febi 101325,106911

Nissan Qashqai 2013 > (J11) model,
X-Trail 2014 > (T32)
Engine: K9K, R9M

Fuel Filter

Fig. 1 febi 101325

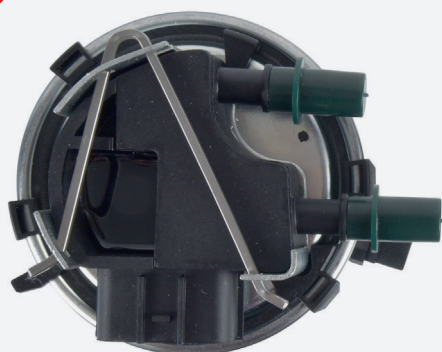
The water in fuel, lamp is illuminated on the vehicles dashboard display after the fuel filter has been replaced.

The incorrect filter has been fitted to the vehicle during servicing, due to a change in specification with the fuel heater/water sensor installed in the filter. This effects Qashqai models built from August 2014 and X-Trail models from December 2014.

The correct fuel filter required for the Qashqai models built before August 2014 and X-Trail models before December 2014 can be identified by a black fuel heater/water sensor inbuilt into the filter (Fig 1).
